Proposed amendments to the eTIR Reference Model

Agenda item 3.c

Informal Ad hoc Expert Group on Conceptual and
Technical Aspects of Computerization of the TIR Procedure
9 -10 March 2011, Geneva

- **New Chapter 2.3.2.17. Advance cargo information activity diagram**

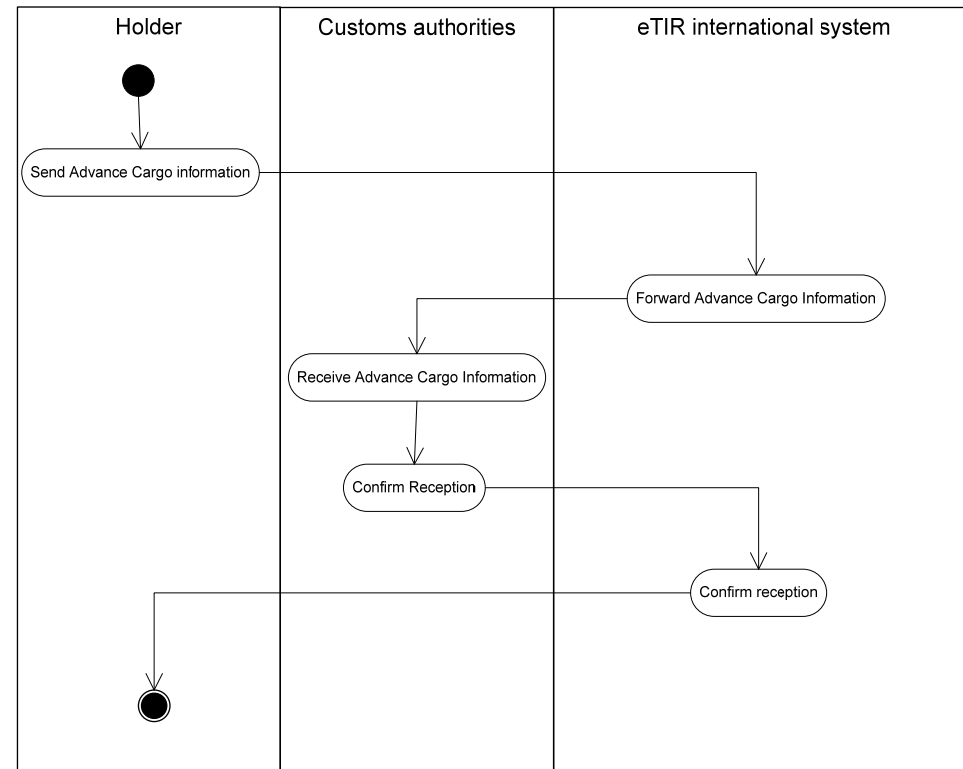
Amendments – Declaration mechanisms

- **New Chapter
3.1.1.2.8
Advance
cargo
information**

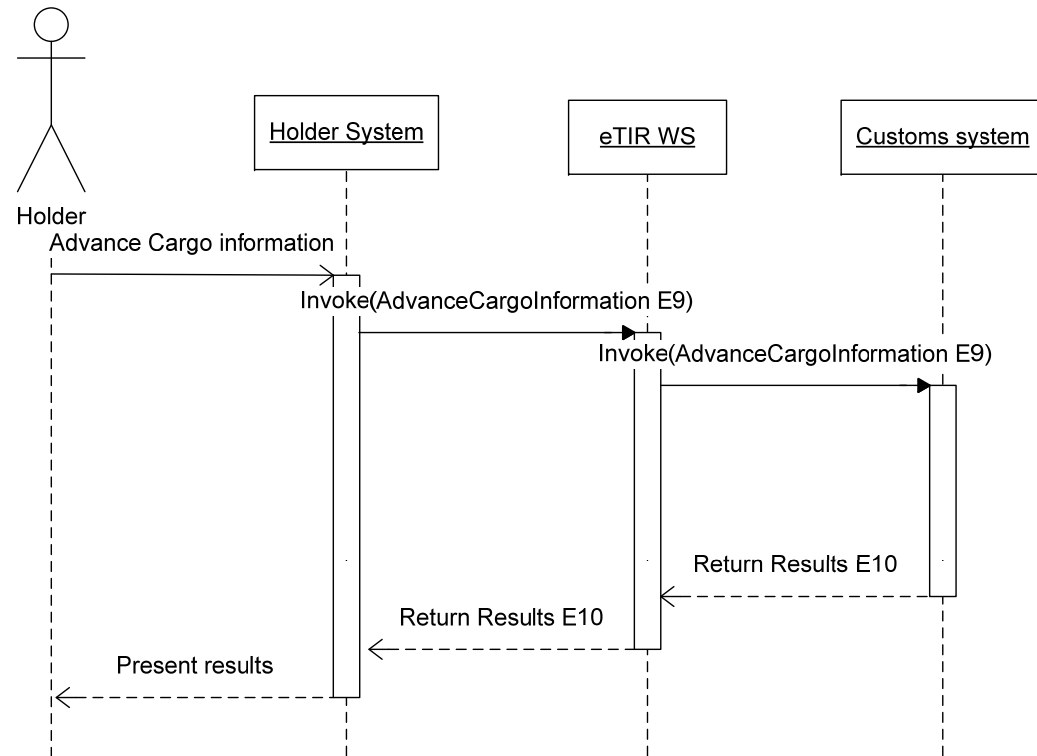
Amendments – Declaration mechanisms

● Chapter 3.1.1.1.5. Query guarantee

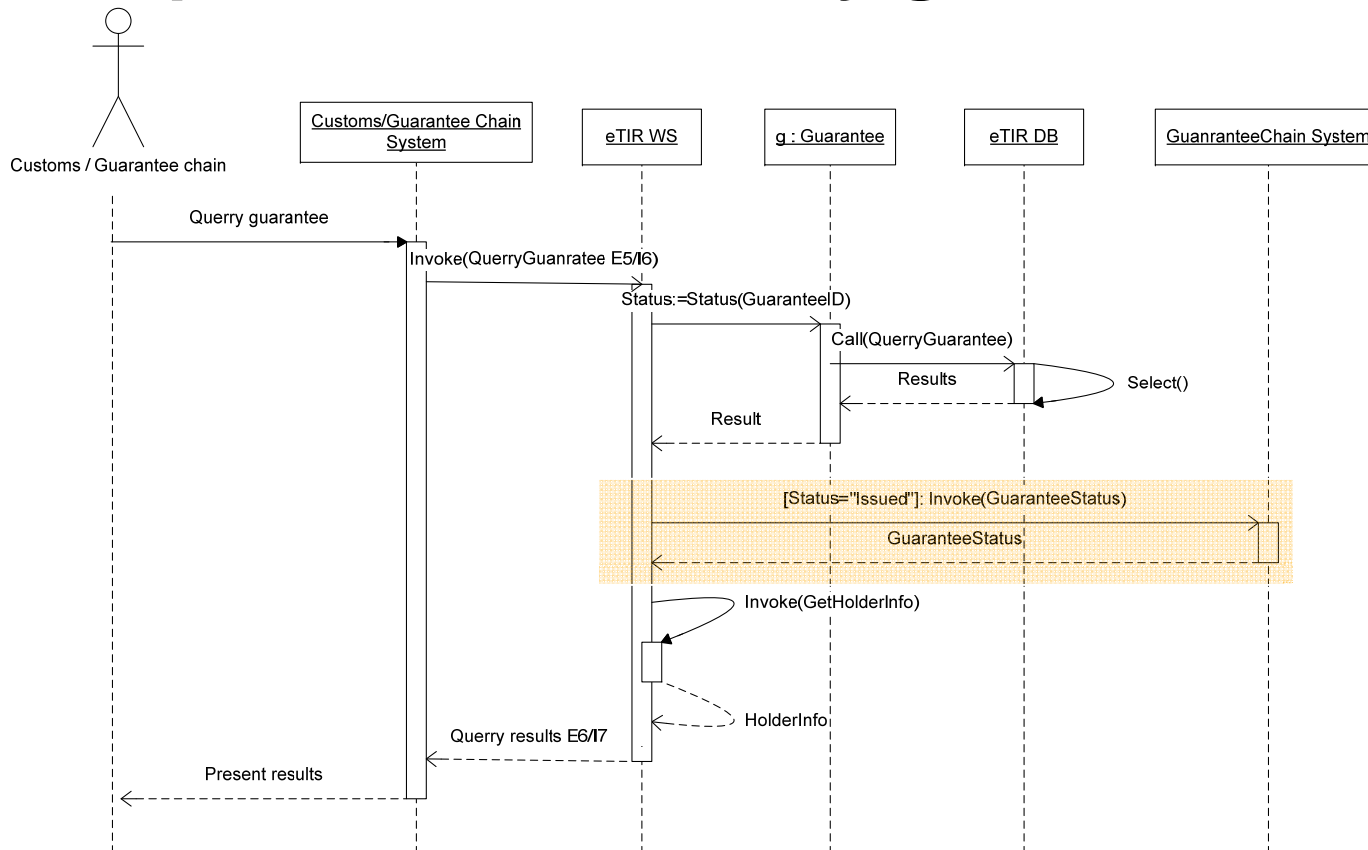
Amendments – Validation of the guarantee

- Chapter 3.1.1.1.4
Accept guarantee

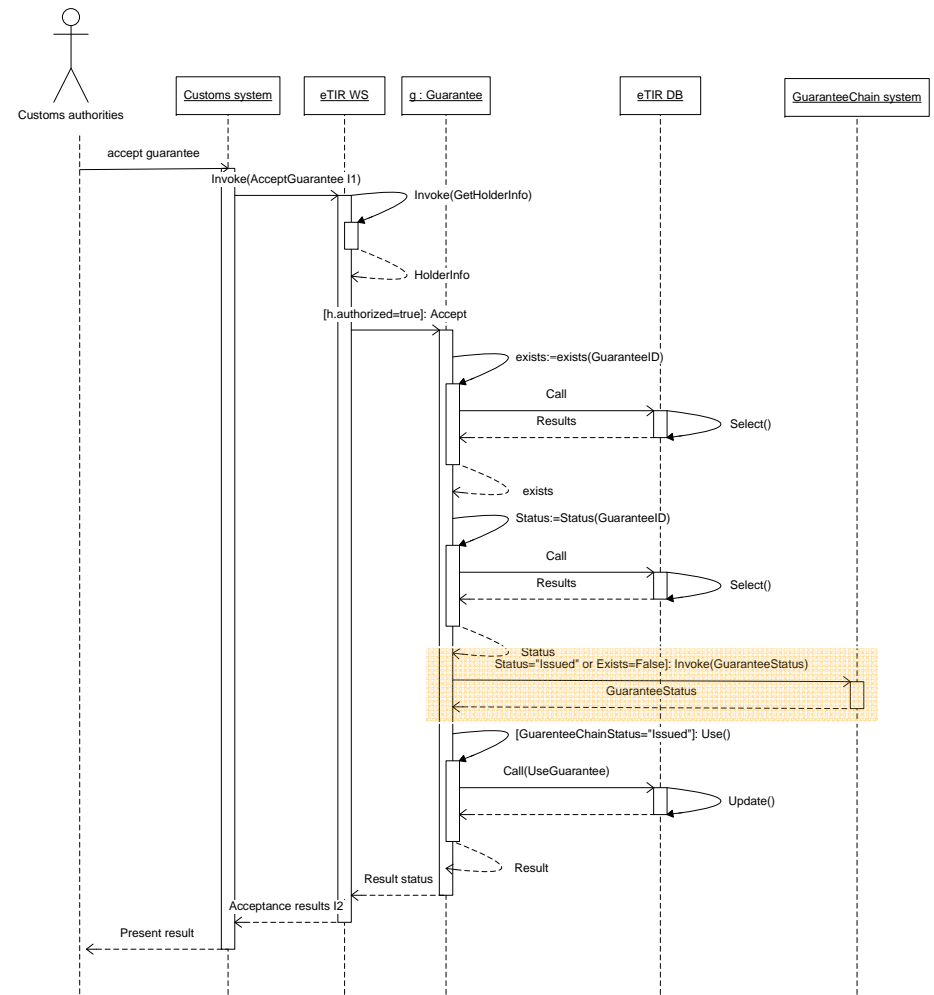
Amendments – Validation of the guarantee
